Agenda
Village of Arlington Heights
Design Commission
Community Room, 3rd Floor

Arlington Heights Village Hall
33 S. Arlington Heights Road
Arlington Heights, IL 60005
February 24, 2015
6:30 PM

DATE: February 24, 2015
TO: Design Commissioners
FROM: Steve Hautzinger, Design Planner
RE: **Village Wide Electronic Signs, Re-Review**

DATE: February 24, 2015
TO: Design Commissioners
FROM: Steve Hautzinger, Design Planner
RE: **DC 15-001, Patton Elementary School, Sign Variation**

Proposed Sign

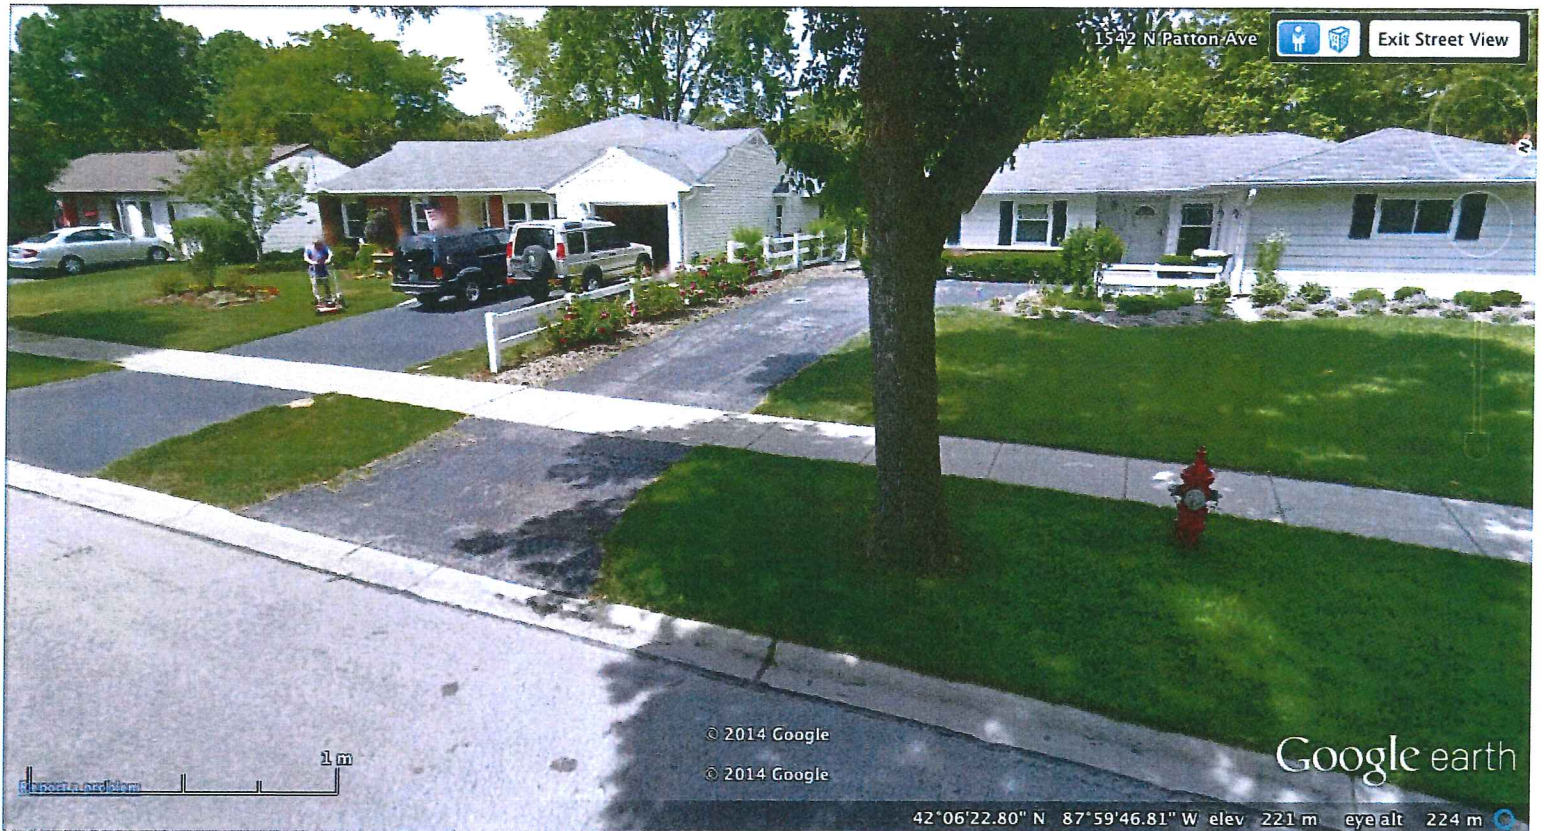
The petitioner is proposing to replace an existing non-conforming 24 sf manual change bulletin board wall sign with a new 24 sf electronic message board wall sign. The new sign is of similar design as the existing sign, and it will be installed in approximately the same location on the east exterior wall of the school. Electronic changeable LED signs are prohibited per the sign code. Patton Elementary School is located in an R-3 One Family Dwelling District surrounded by single family homes. The proposed wall sign will be set back from the property line approximately 35 feet, and will face single family homes directly across the street.

Of the four options listed, Staff recommends that the Design Commission proceed with either Option 1 or Option 2 regarding the proposed electronic message board wall sign variation request for *Patton Elementary School* located at 1616 N. Patton Avenue. These recommendations are based on the plans received 1/5/15, Federal, State, and Village Codes, regulations, and policies, and the issuance of all required permits.

FRONT ELEVATION

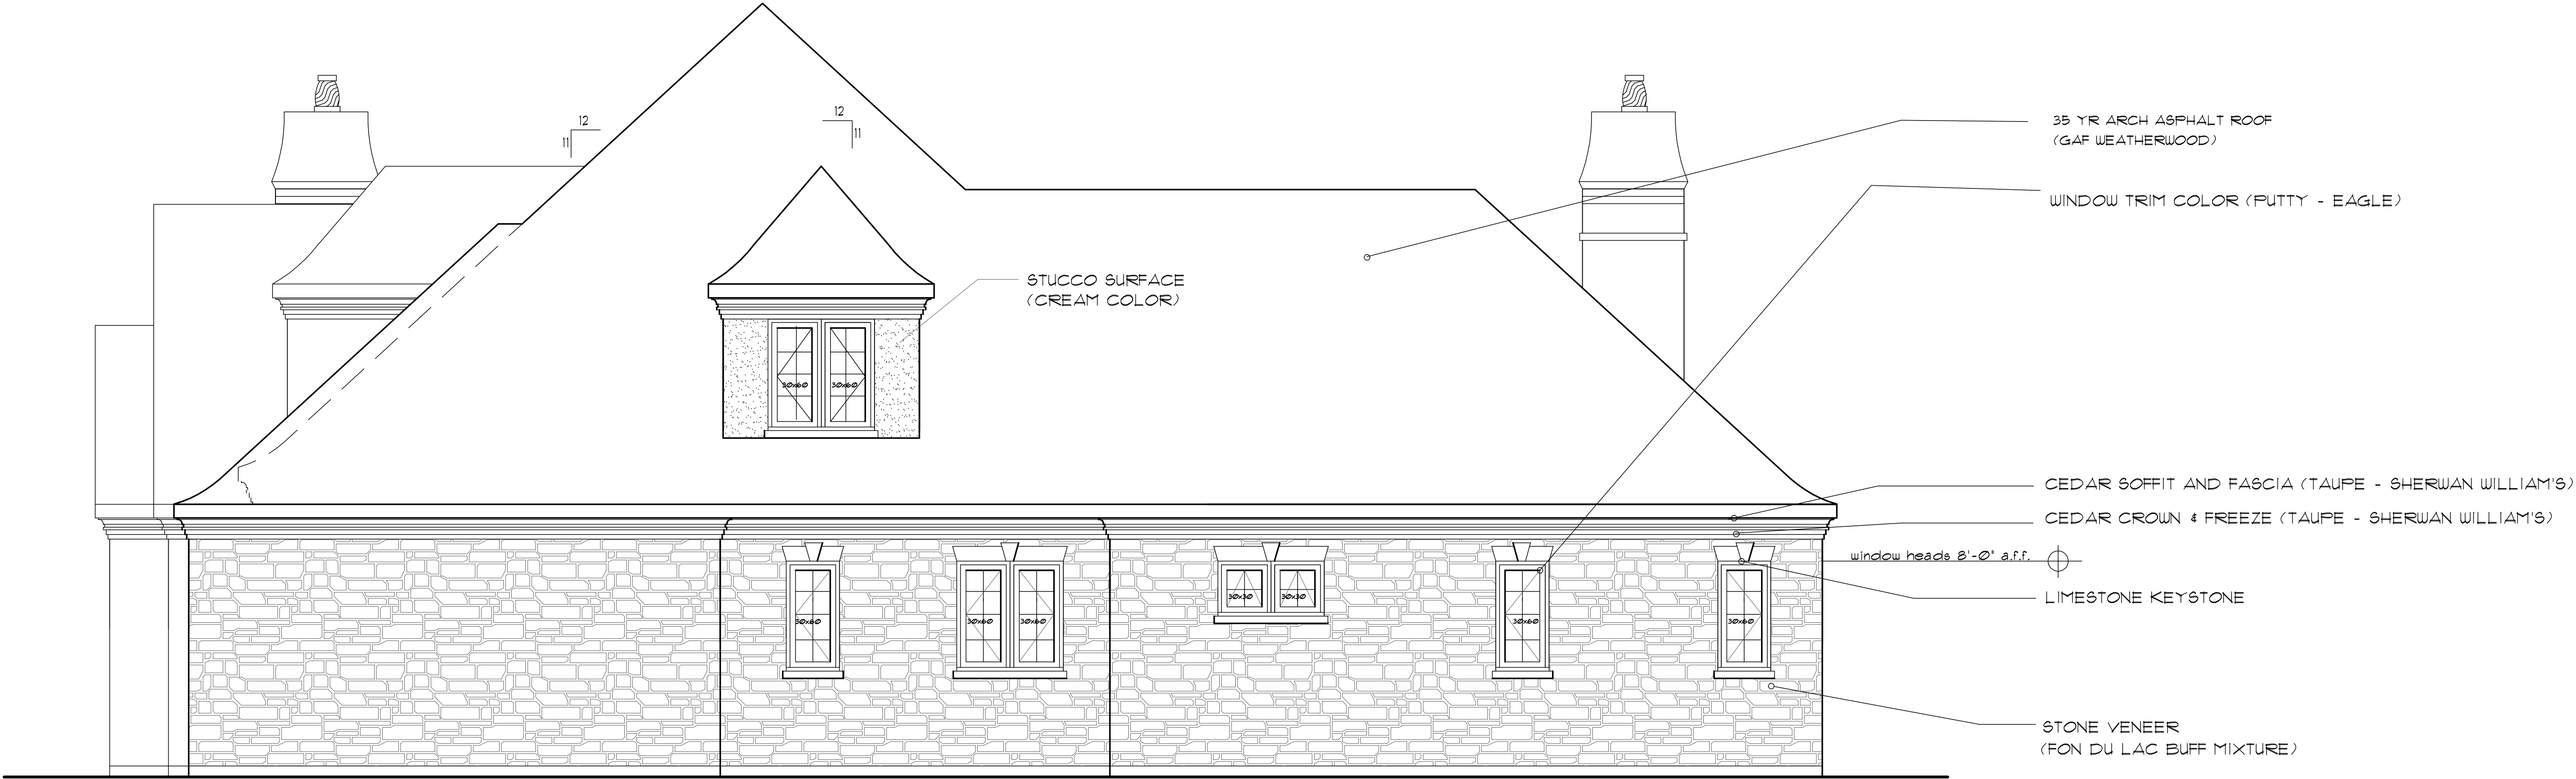
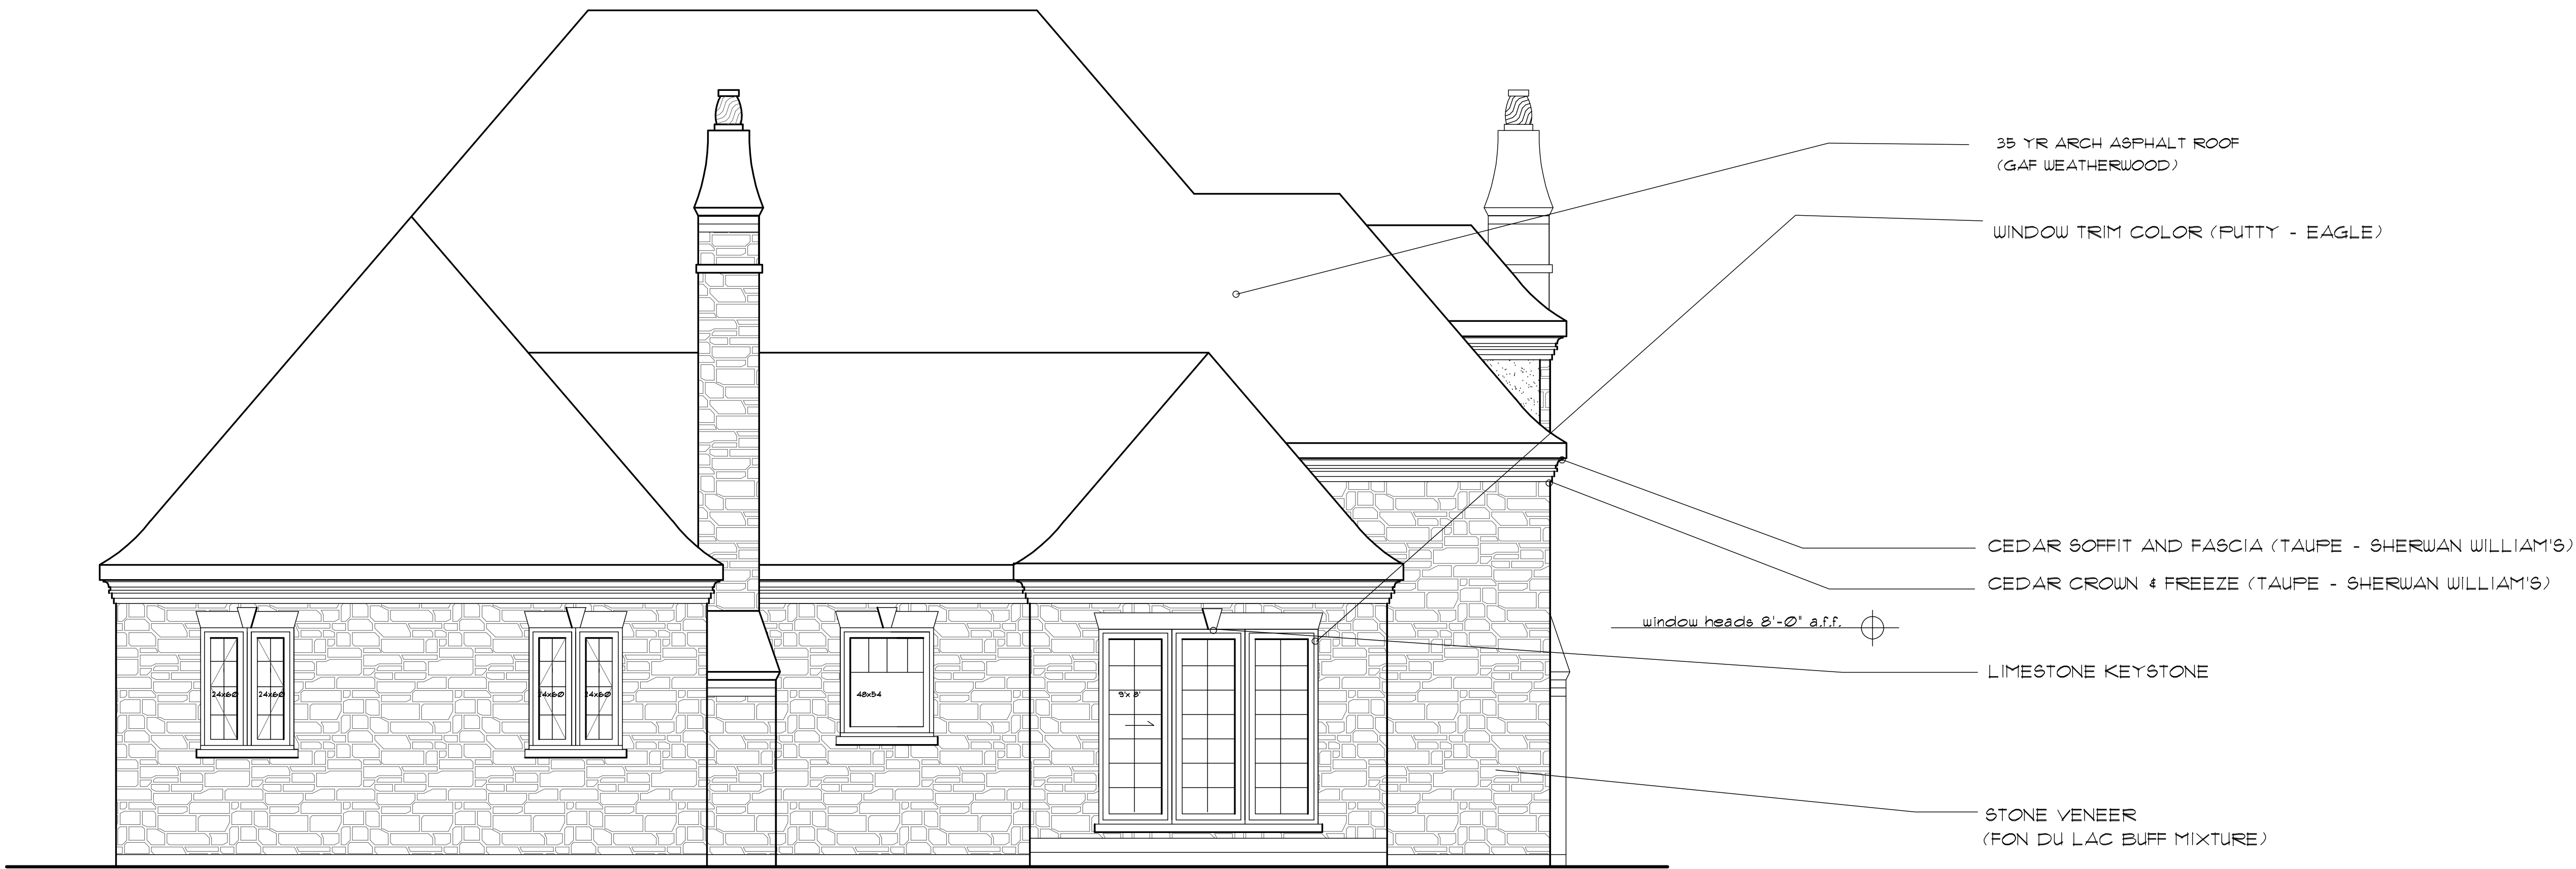
1. Consider a more historic style feature window on the south elevation.
2. This review represents design approval only and should not be construed to be an approval of, or to have any other impact on, any other zoning and/or land use issues or decisions that stem from zoning, sign code or building or any other reviews.
